Response to Referee #1

This is a WRF modeling study of the wakes of future offshore wind energy areas planned along the US east coast. It considers three scenarios of offshore wind development: Vineyard Wind only, lease areas in the Mid-Atlantic, and lease + call areas in the Mid-Atlantic. An impressive modeling effort was undertaken, with nested high-resolution WRF runs for one year repeated for the three scenarios above, plus the control case with no farms, plus runs with 0% and 100% TKE added. The team had also numerical noise issues, as seems to be the norm when the wind farm parameterization is turned on, and therefore had to deal with several additional runs to take care of it. The paper is definitely worth publishing as it includes interesting and valuable results. It is exceptionally well written. It was a pleasure to read such a good paper!

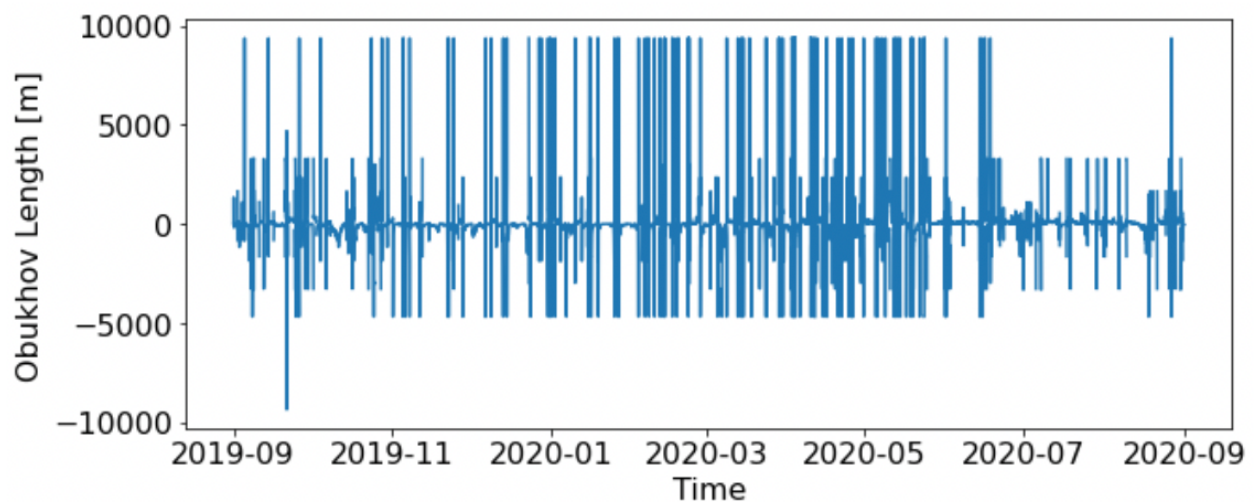
- Line 408 - 409: Could you add another line in figure 11 representing the stability conditions. This would make it easier to see that the power production is indeed more closely linked to hub-height wind than stability.

Unfortunately, a timeseries plot of stability conditions at the same granularity (as seen below) does not easily facilitate comparison. This is why we have chosen to show stability with longer temporal averages using bar charts and grid plots.

Timeseries of the Obukhov Length over the yearlong period.
